Meeting Date: July 23, 2025

AGENDA MEMORANDUM

Title: 210 Third Street Site Development Plan Amendment (Scileppi's 2nd Phase)

Figure 6: Demolition Footprint

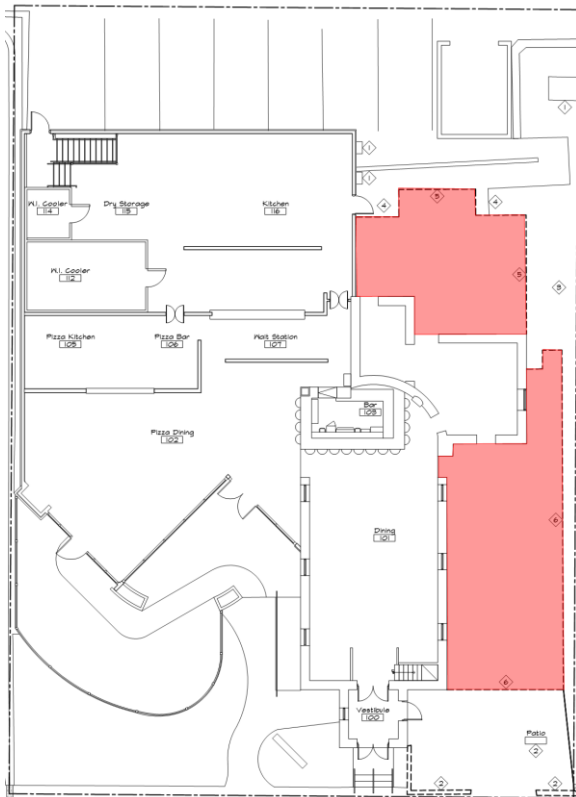
The proposed SDP amendment includes the removal of existing shed additions, totaling approximately 1,402 square feet, located on the west side of the historic church and originally constructed in 1981. These will be replaced with new additions totaling approximately 1,350 square feet, resulting in a net reduction of 52 square feet. The new structures will have a maximum height of 15 feet and will be clad in dark bronze PAC-CLAD rigid metal siding, consistent with the recent addition on the east side of the church. Additionally, the existing patio in front of the west addition will be reconstructed as part of the project.

Figure 9: West Elevation

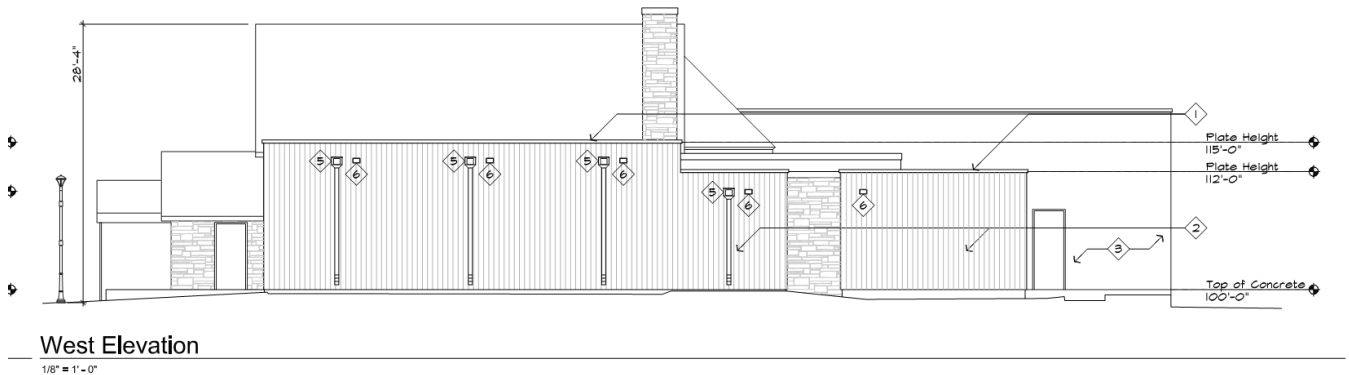
A flat roof is proposed for the addition with a total height of 15 feet. The property is in the Downtown Core district which has a four-story limit, with a maximum height of four stories and 60 feet.

Analysis: The proposed addition's maximum height is 15", which is shorter than historical church structure. This meets the Downtown Core District, which the property is located within, criteria of four stories and 60 feet.
